ICC CODES - PUBLIC COMMENT FORM

Indicate the Code Change Proposal Number that is being addressed by this Public Comment: **RB265-13**

RB264-13

R507.1, R507.5, Figure R507.5, Table R507.5, R507.5.1, R507.6, Figure R507.6, Table R507.6, R507.7, R507.8,

FIGURE R507.5
TYPICAL DECK JOIST SPANS

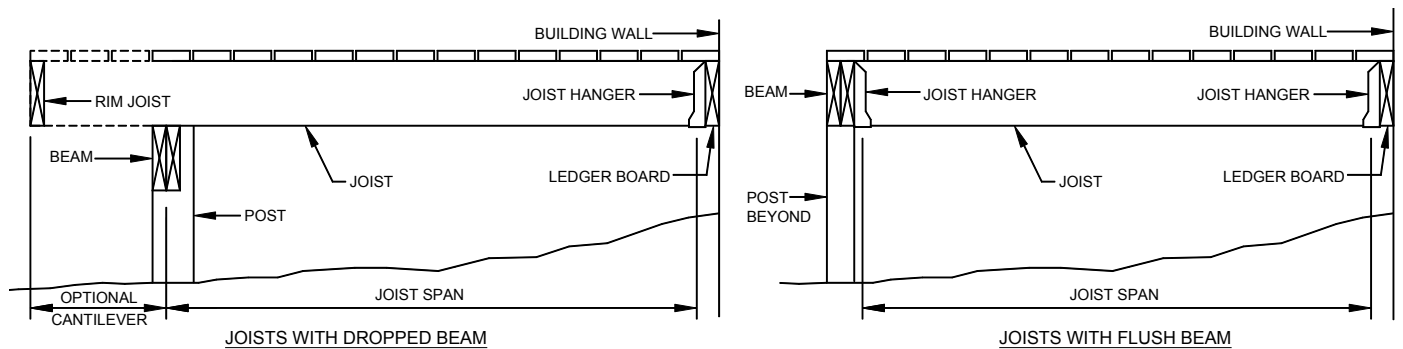
R507.5 Allowable deck joist spans. Spans for wood deck joists, as shown in Figure R507.5, shall be in accordance with Table R507.5. Deck joist shall be permitted to cantilever a maximum of one-fourth of the joist span.

**FIGURE R507.6
TYPICAL DECK BEAM SPANS**

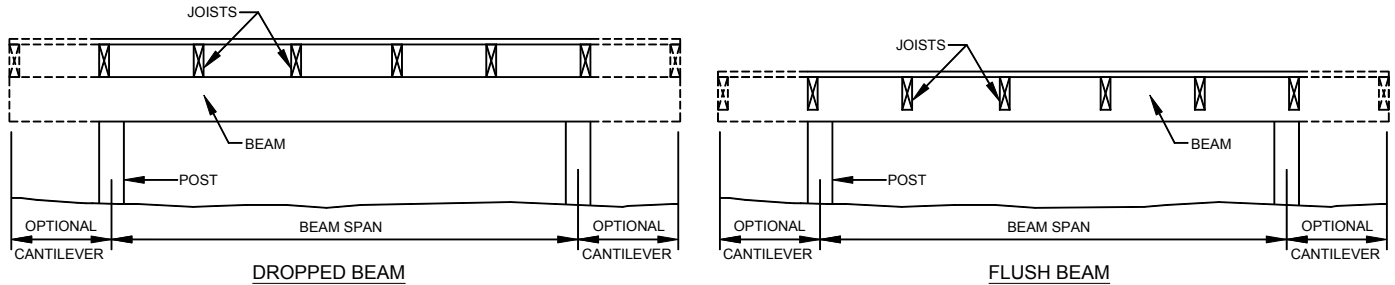
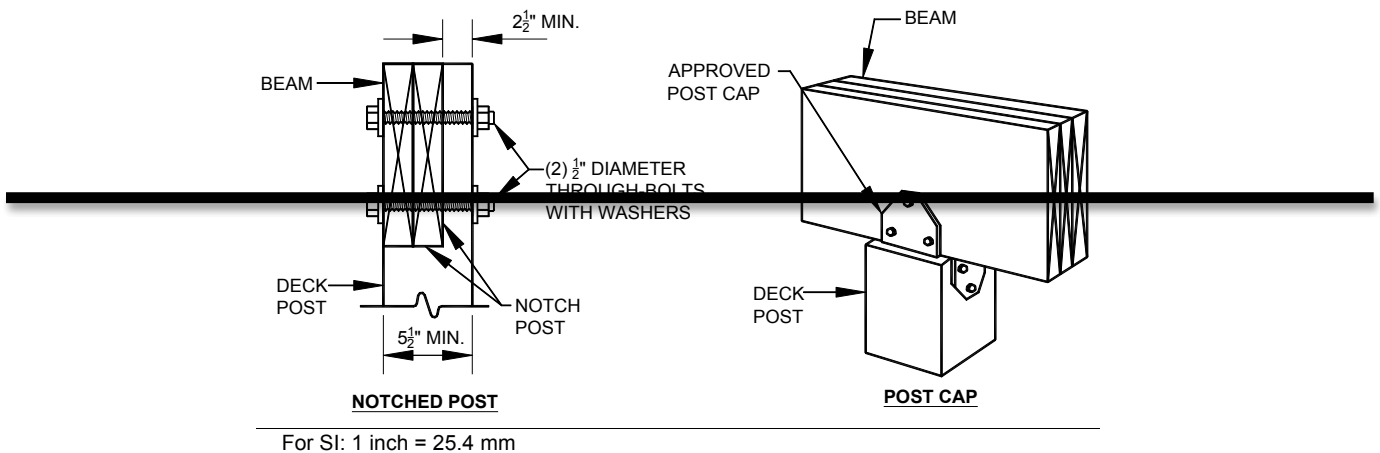
R507.6 Deck Beams. Spans for deck beams, as shown in Figure R507.6, shall be in accordance with Table R507.6. Beam plies shall be fastened with two rows of 10d (3" x 0.128") threaded nails minimum at 16 inches (406 mm) on center along each edge. Beams shall be permitted to cantilever at each end up to one-fourth of the beam span. Splices of multi-span beams shall be located at interior post locations.

FIGURE R507.8.2
TYPICAL DECK POSTS TO DECK FOOTINGS

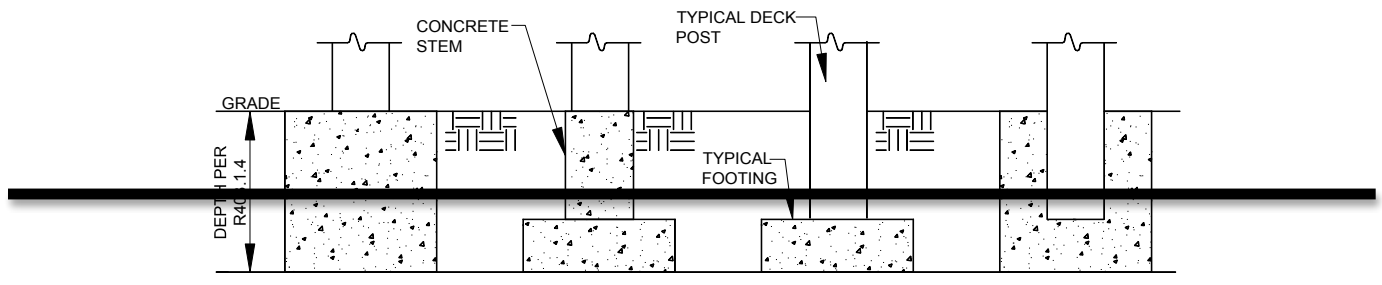
R507.8.2 Deck post to deck footing. Posts shall bear on footings in accordance with Section R403 and Figure R507.8.2.
